**STAFF REPORT: OCTOBER 9, 2024, REGULAR MEETING**

**APPLICATION NUMBER: HDC2024-00522**

**ADDRESS: 19566 CANTERBURY**

**SCOPE: REPLACE STEEL WINDOWS WITH COMPOSITE WINDOWS**

*Front (southwest facing) view of subject property, June 2022 photo by staff.*

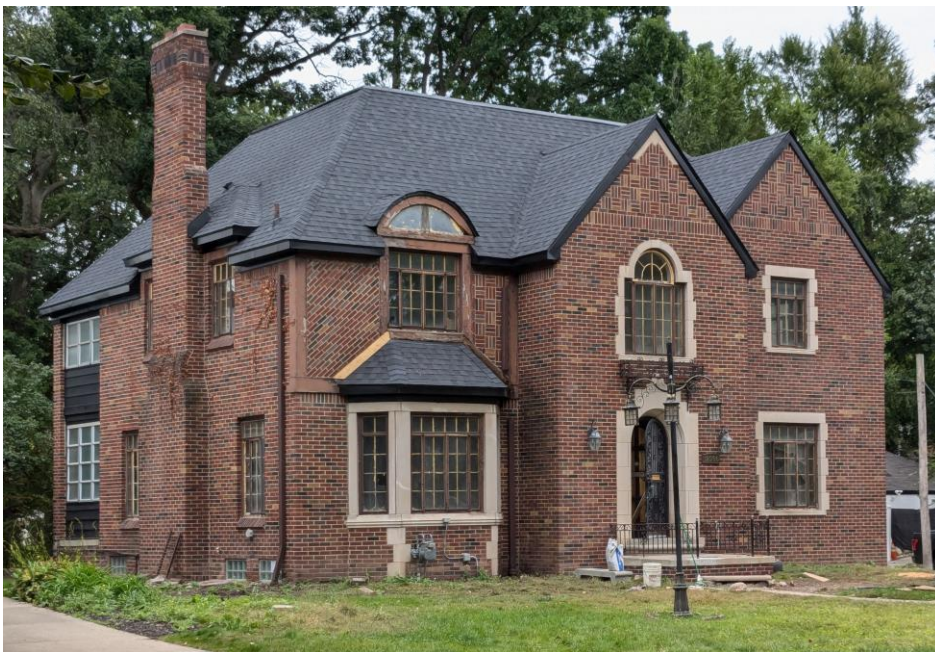
19566 Canterbury faces southwest onto Canterbury Road; located on a corner lot, it also presents a prominent façade southeast to Chesterfield Road. It is a two story, Neo-Tudor house built in 1941. Subject of this application, rolled-steel windows are prominent. Other character-defining features on this relatively simple, planar facade include brickwork in various contrasting patterns, stone-tabbed window and door surrounds, and a prominent wall chimney.
